PORTLAND STATE UNIVERSITY

**Blumel Hall Remodel RFP for
General Contractor (GC) Services**

ADDENDUM #3

June 4, 2012

new work - existing ADA units

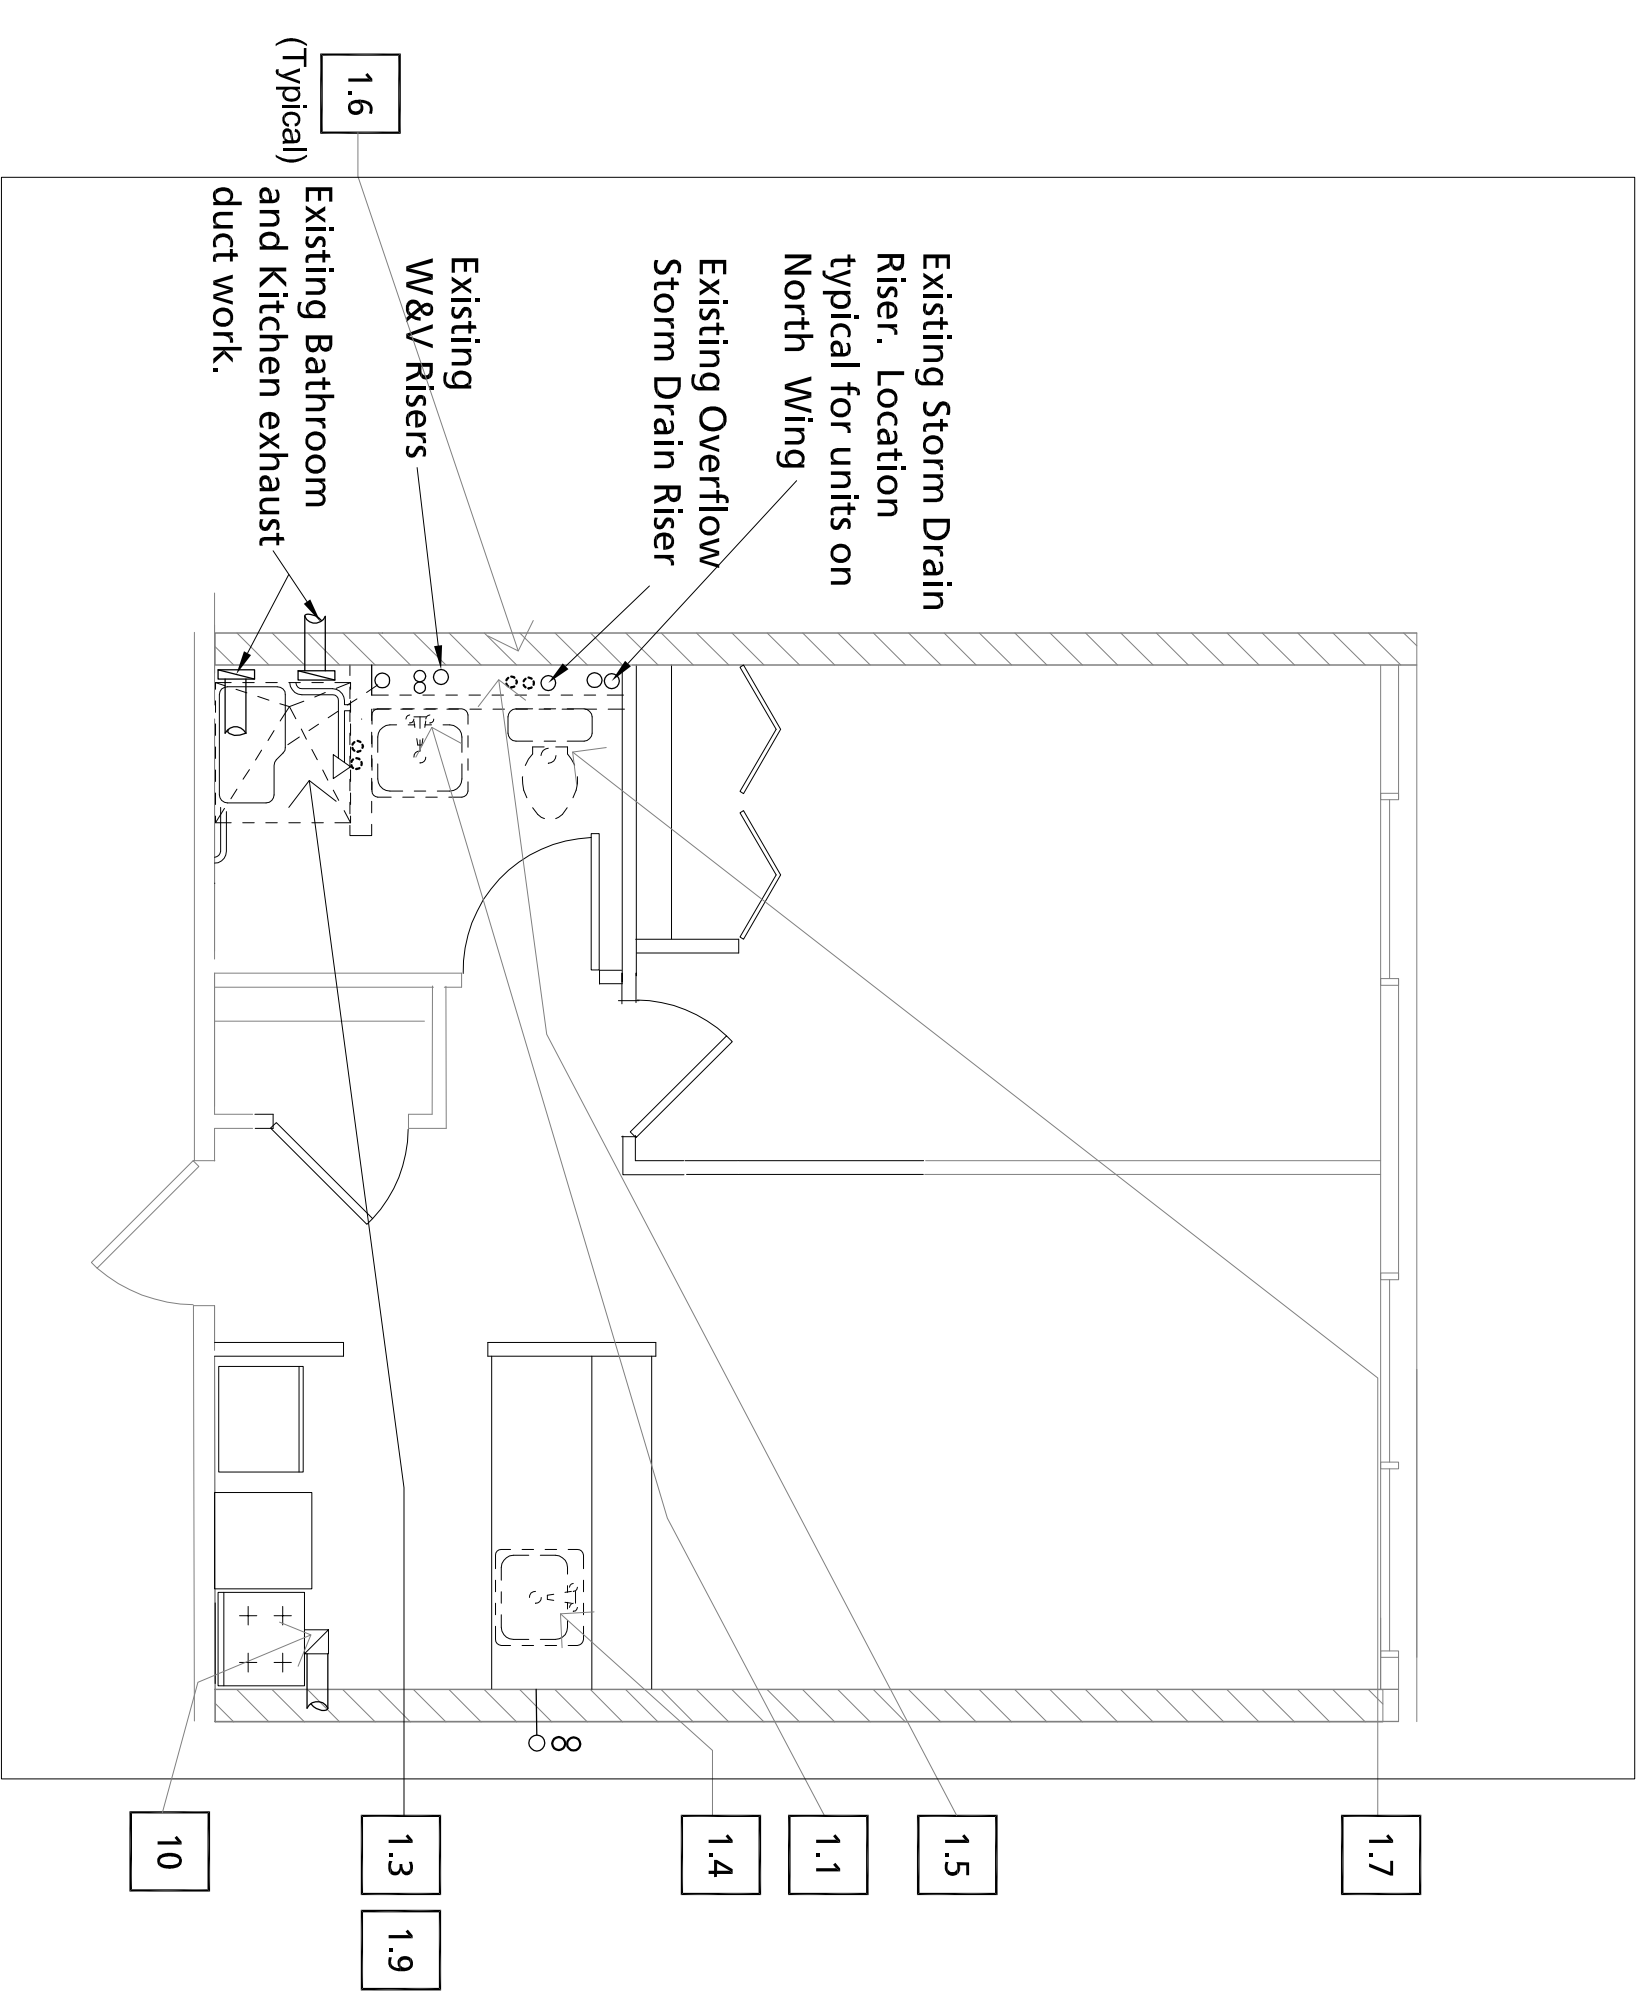
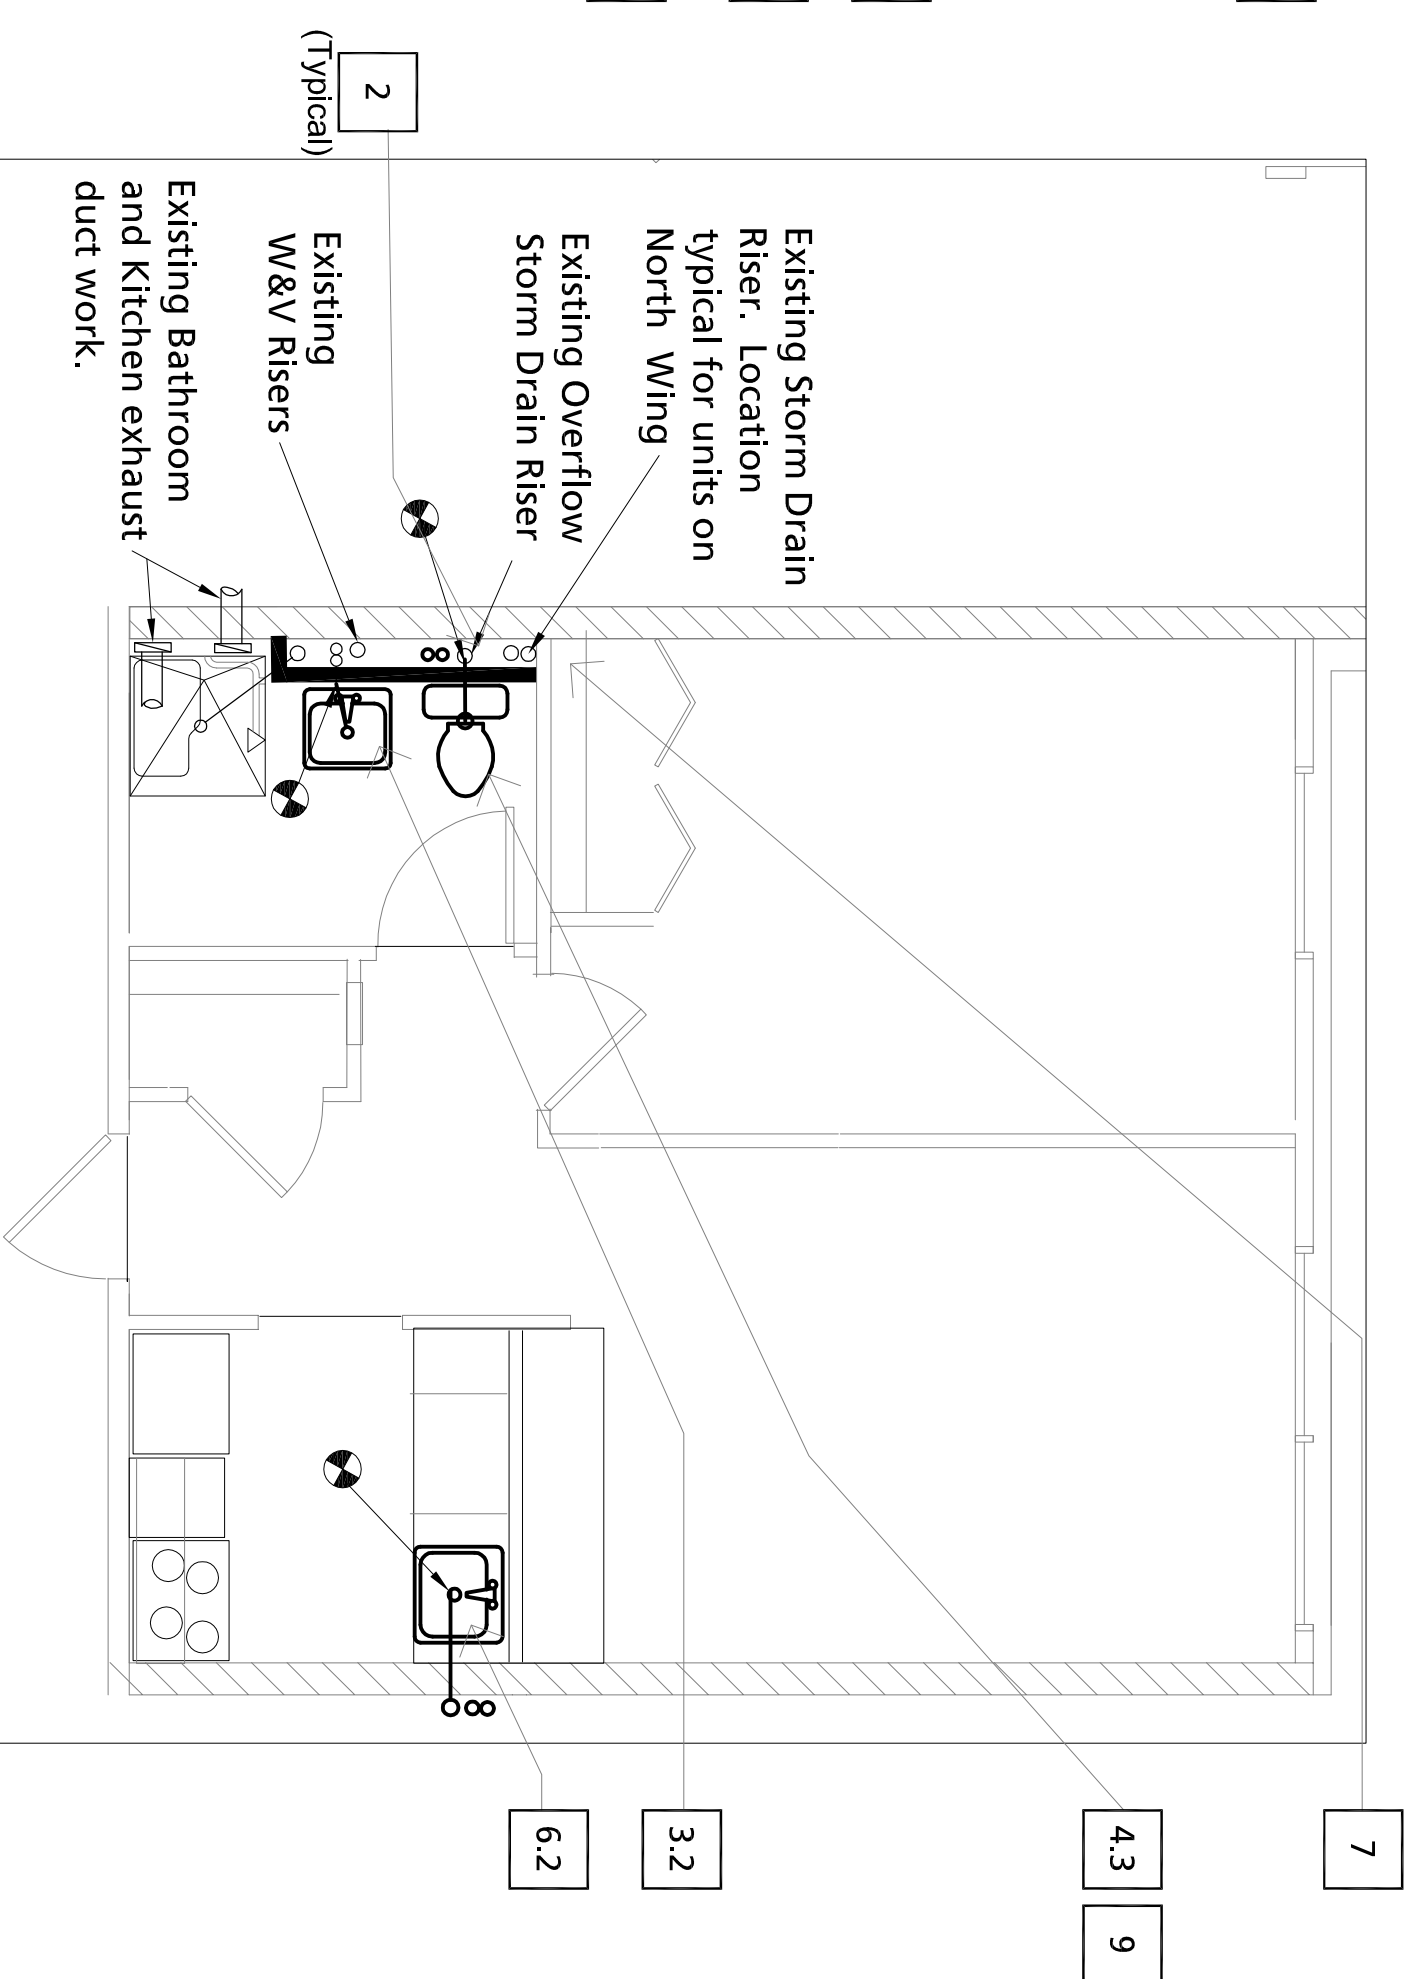
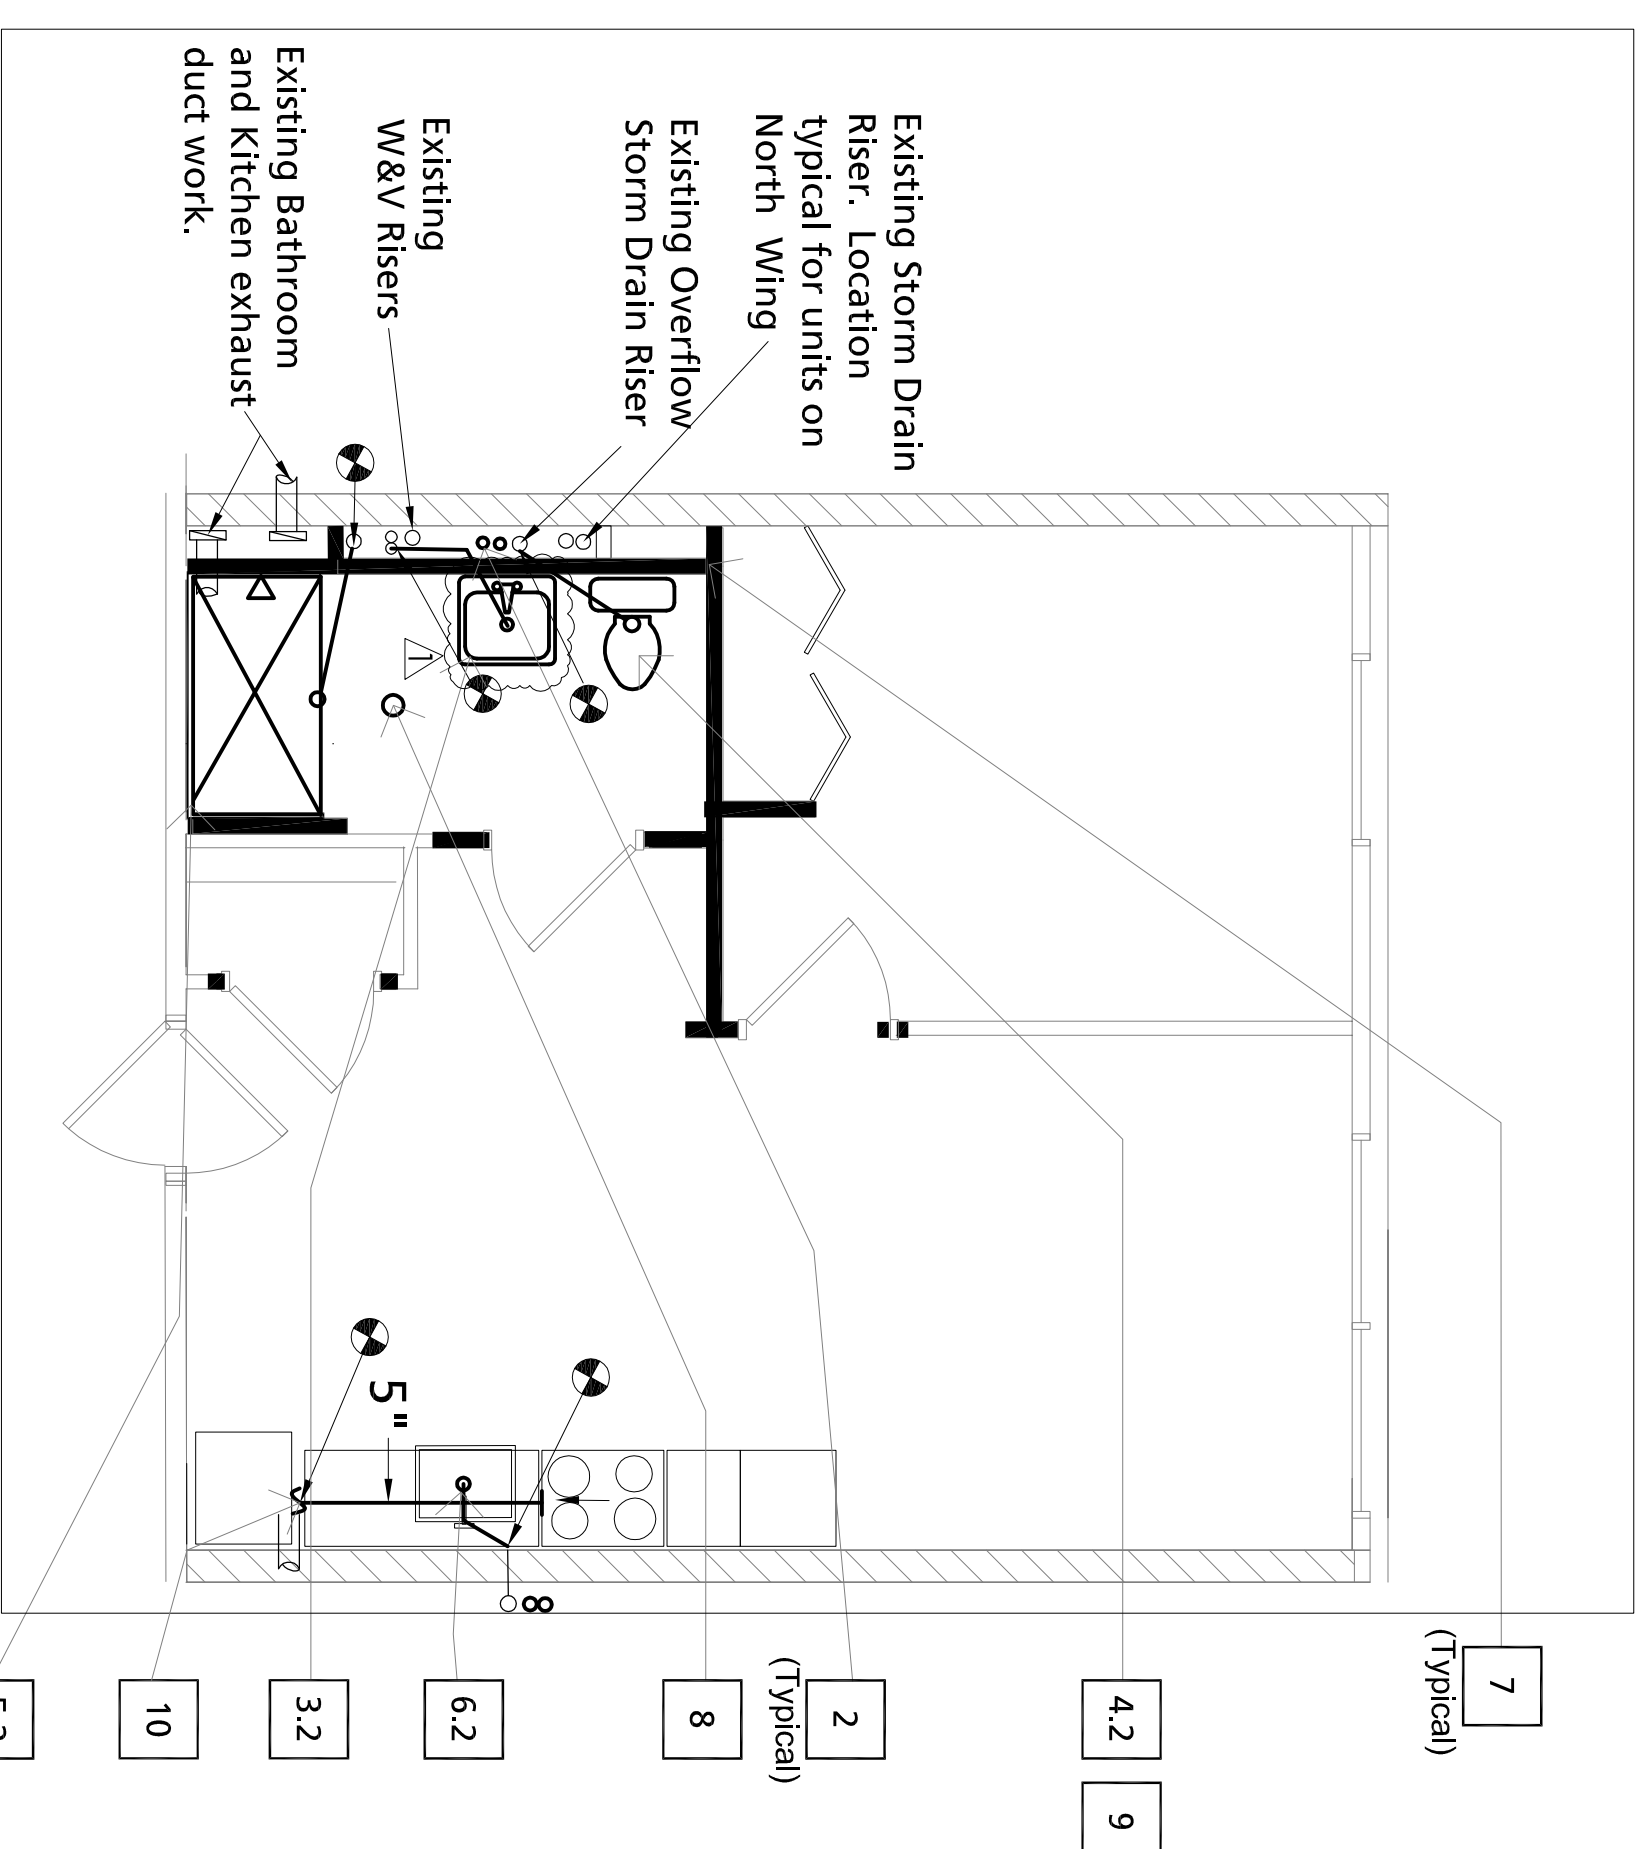
15. Q: Clarify scope of test and balance for each MAU. Is it to be balanced at roof level only, or at each floor? **Answer: Only at roof level.**
16. Q: Clarify scope of HVAC in modified toilet rooms as shown on MP-12 and MP-13. **Answer: The only HVAC work associated with MP12 and MP13 is in the new ADA rooms, reference note 10 on MP12 and "new work-ADA units" on MP13.**

* SEE MP12
